WP-8X4X OS Release Note,

Version 1.5.0.0 [April, 6, 2010]

OS Version 1.5.0.0 [April, 6, 2010]

Retain the previous registry

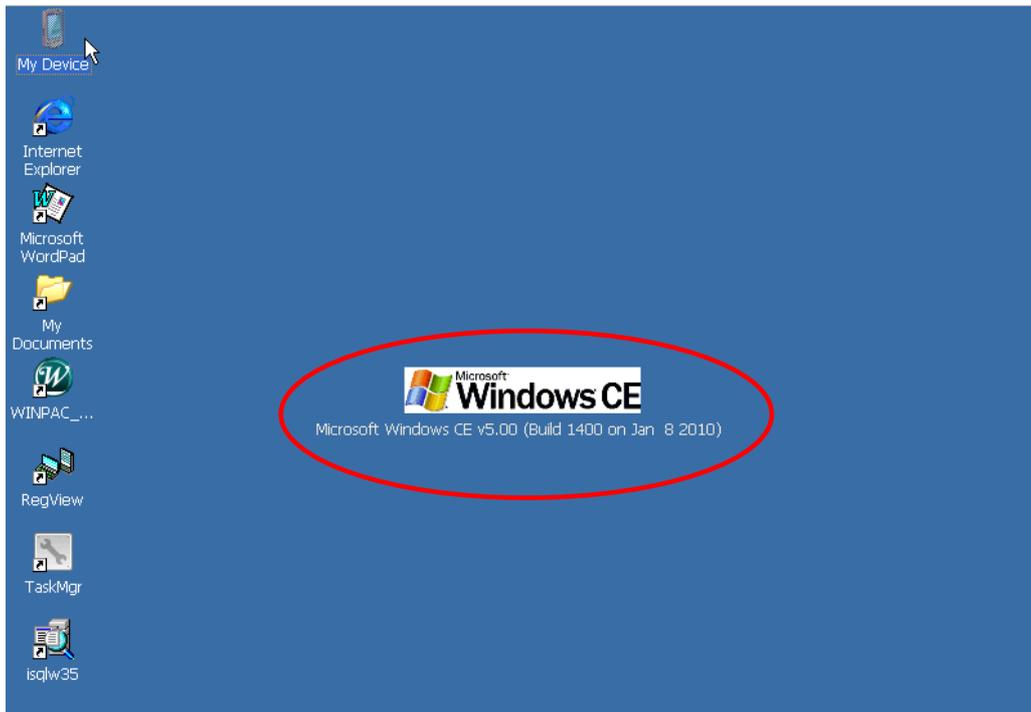
Check the “Retain the current registry at next reboot” checkbox while running the installation package file (**WP8x4x_20100406_Ver.1.5.0.0_xx.exe** or **later**). The previous registry will be backup on the specified disk, and the all settings of the registry will be restored to the new OS at next reboot after updating the OS using the installation package file.

All the previous settings on the registry will be restored to the new OS except the keys below.

1. **HKEY_LOCAL_MACHINE\Drivers\BuiltIn**
2. **HKEY_LOCAL_MACHINE\CPDAS\OS**
3. **HKEY_LOCAL_MACHINE\HARDWARE\MODULETYPE**

Remove "Microsoft Windows CE v5.00" message from the desktop

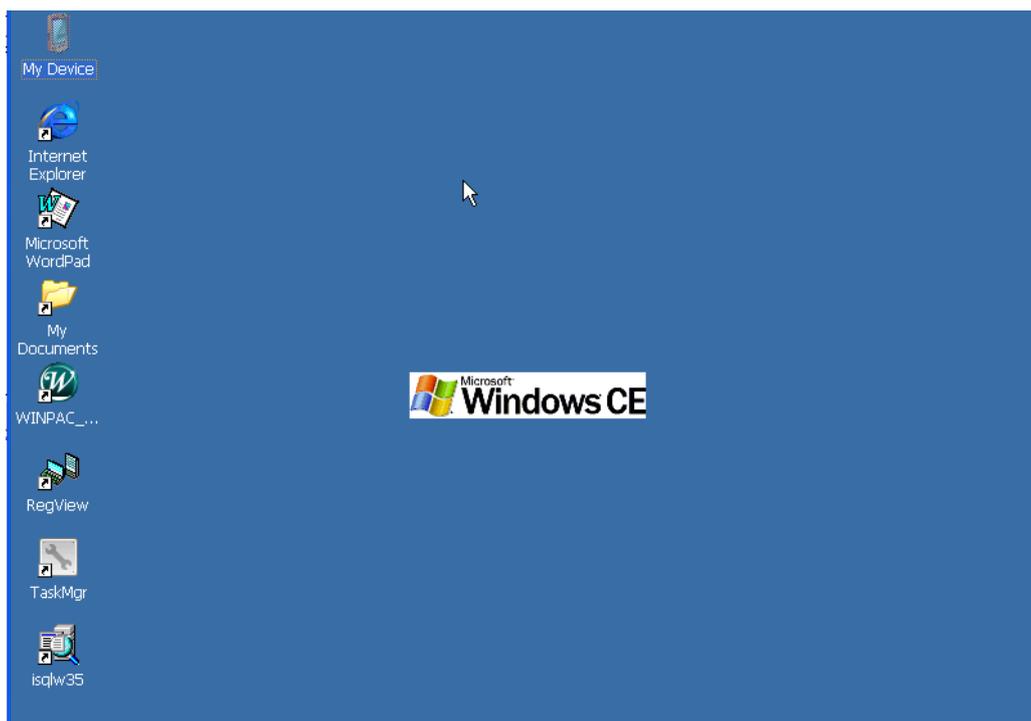
The desktop of WP-8x4x in OS V1421 or earlier

The desktop of WP-8x4x in OS V1433 or later

Disable Power management in the factory default

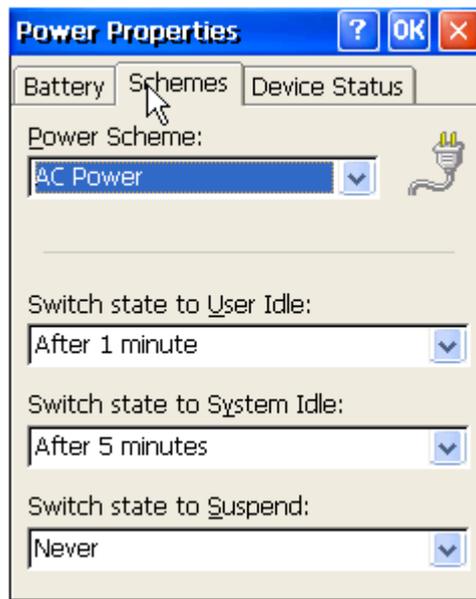
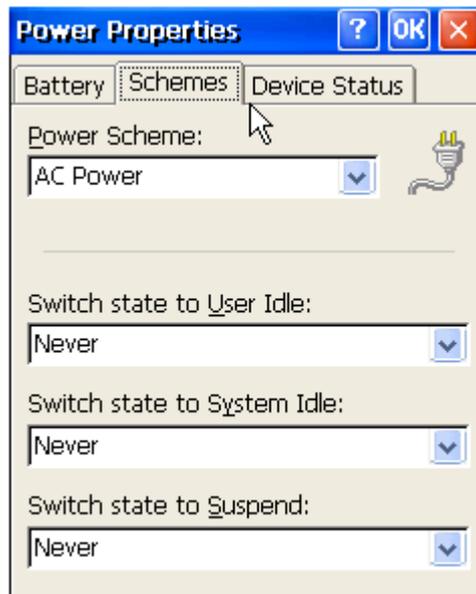
The Power Scheme of AC Power in OS V1421 or earlier

The Power Scheme of AC Power in OS V1433 or later

In **V1421** or **later** of WinPAC, the display will be turned off automatically, while the system state is system idle.

In **V1500** or **later** of WinPAC, the User and System Idle time set to 0 (Never) and the display will not be turned off automatically.

Set the time for User and System Idle in this version, and the power management is also allowed to control turn the display On/Off.
